**CITY OF MERIDIAN
FINDINGS OF FACT, CONCLUSIONS OF LAW
AND
DECISION & ORDER**

In the Matter of the Request for a Conditional Use Permit (CUP) for a Vehicle Washing Facility on 3.13-Acres of Land in the C-C Zoning District for Ultra Clean Carwash per Requirement of the Rezone Ordinance (#02-940), Located at 715 E. Fairview Ave., by KM Engineering, LLP.

Case No(s). H-2023-0073

SUBJECT: Ultra Clean Carwash – CUP
[H-2023-0073](#)

C. Building Elevations (dated: 10/26/23)

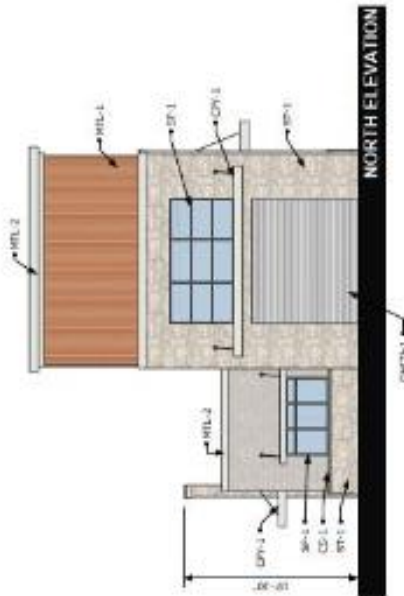
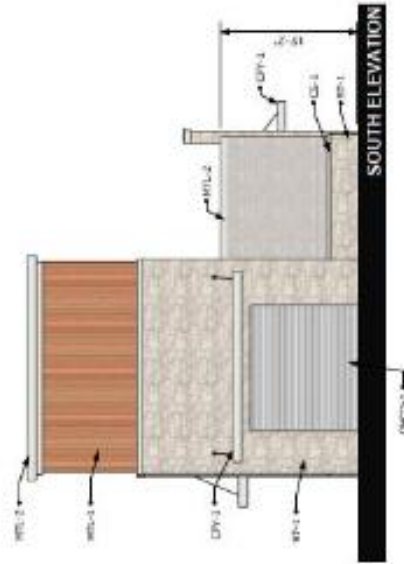
Building Elevations: Conceptual building elevations were submitted as shown in Section VIII.C for the proposed vehicle washing facility that depict modulation and articulation on all facades with belly bands, awnings, metal cladding designed to look like cedar, glazing and other architectural features. A mix of materials are proposed consisting of burnished CMU, natural stone, cedar rendition metal cladding and other natural materials with metal roofing and canopies. The color scheme will include various browns, tans, and other warm earth tones. **The final design is required to be consistent with the design standards listed in the [Architectural Standards Manual](#).**

D. Turbine Sound Intensity Exhibit

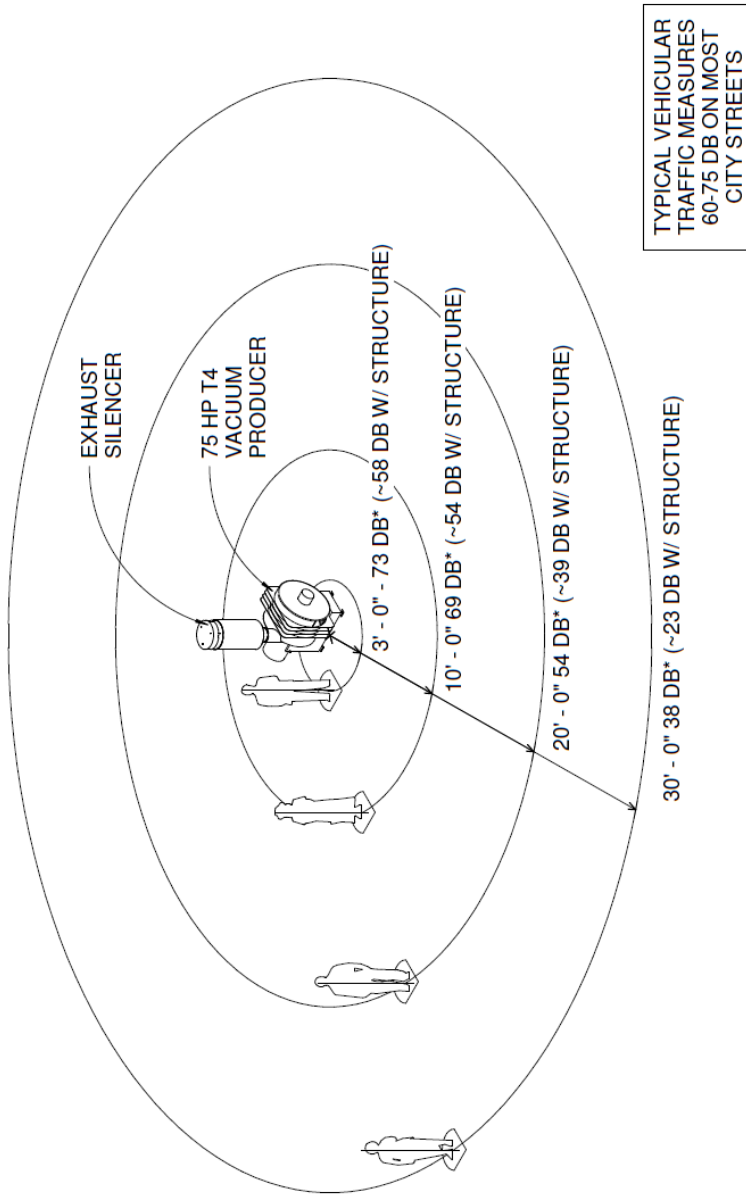
Noise: The proposed use is required to comply with the City's noise ordinance (MCC [6-3-6](#) – Noises Creating Public Disturbance). The Applicant states each vacuum will be powered by a larger turbine that will have an exhaust silencer/muffler to mitigate any noise concerns. A sound intensity exhibit for the turbines was submitted, included in Section VIII.D of this report, that shows the sound decibel (DB) readings at different intervals up to 30' away (which measures 38 DB at 30') with a comparison of typical vehicular traffic at 60-75 DB on most City streets.

7. Each vacuum turbine shall have an exhaust silencer/muffler to mitigate noise impacts to

adjacent neighbors as proposed.
